RE: Data Responses, Set 3B
Cosumnes Power Plant (01-AFC-19)

COSUMNES POWER PLANT (01-AFC-19)

DATA RESPONSE, SET 3B

Figure W&SR-247. 100-year floodplain of Clay Creek, calculated for area adjacent to CPP.

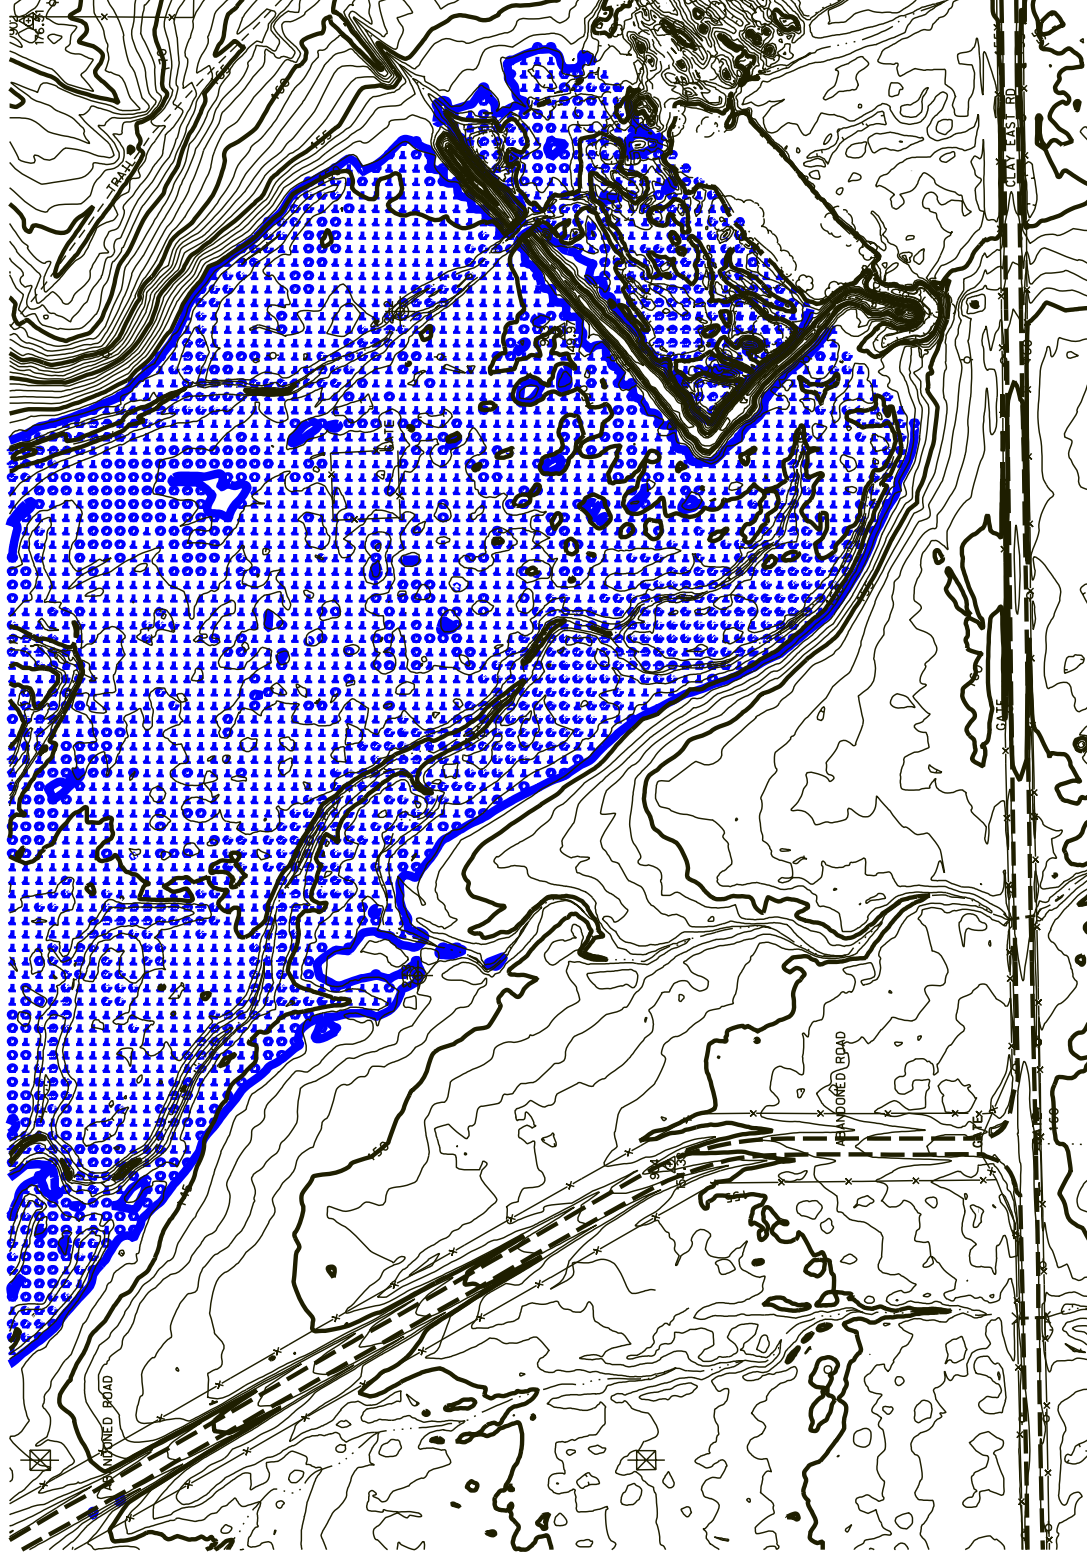
247. Please provide a map showing the location of the 100-year floodplain of Clay Creek which includes the water surface elevations on and adjacent to the CPP site.

Response: Figure W&SR-247 shows the location of the 100-year floodplain of Clay Creek based on HEC modeling previously provided to the CEC staff. See also, Figure W&SR-250a.
